Access Compliance Report

Public Rights-of-Way

Intersection ID: 43581	Main Street: LUKES_DR	Cross Street: LINDA_VISTA_LN	Location:	N
ADA ID: FEFE7B3AFADD	Ramp Type: PerpDiag	Initial Pass/Fail: Fail	Overall Compliance: No	Severity Score: 35

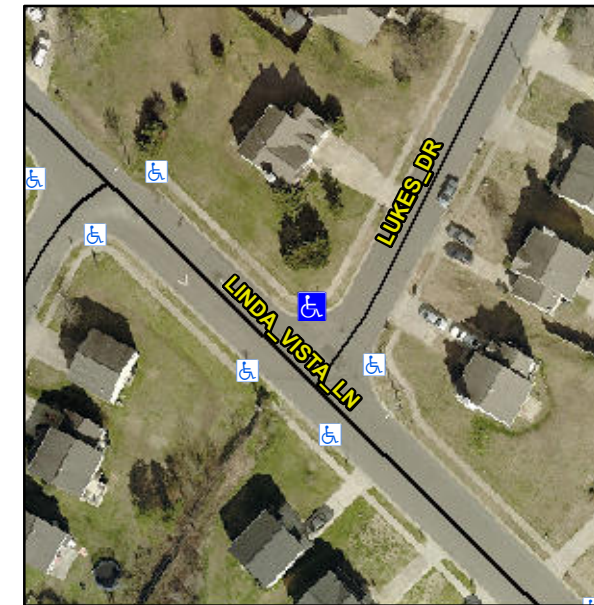
Not Found, R304.5.1

Compliance	Description	Data	Compliance	Description	Data
N/A	Ramp Length (in)	94.5	Yes	Ramp Slope (%)	8.2
No	Ramp Width (in)	30.5	Yes	Ramp XSlope (%)	1.3
N/A	Flare Type LT	N/A	N/A	Flare Type RT	N/A
N/A	Flare Slope LT (%)	N/A	N/A	Flare Slope RT (%)	N/A
N/A	Flare Traversable LT?	N/A	N/A	Flare Traversable RT?	N/A
N/A	Landing Length (in)	N/A	N/A	DWS Provided?	N/A
N/A	Landing Width (in)	N/A	N/A	DWS Contrast?	N/A
N/A	Landing Slope (%)	N/A	N/A	DWS Length (in)	N/A
N/A	Landing X Slope (%)	N/A	N/A	DWS Full Width?	N/A
N/A	Landing Curb? (Y/N)	N/A	N/A	DWS Offset (in)	N/A
N/A	Shared Landing?	N/A			
N/A	Gutter Ponding?	N/A	N/A	Gutter Slope (%)	N/A
N/A	Gutter Lip Ht (in)	N/A	N/A	Gutter X Slope (%)	N/A
N/A	Painted X Walk1?	No	N/A	Painted X Walk2?	No
	X Walk 1 Direction	To SW		X Walk 2 Direction	To SE
N/A	X Walk 1 Width (in)	N/A	N/A	X Walk 2 Width (in)	N/A
	X Walk 1 Slope (%)	8.3		X Walk 2 Slope (%)	2.6
	X Walk 1 X Slope (%)	2.0		X Walk 2 X Slope (%)	2.5

Remove & Replace Curb Ramp With Two New Directional Ramps or Equivalent.
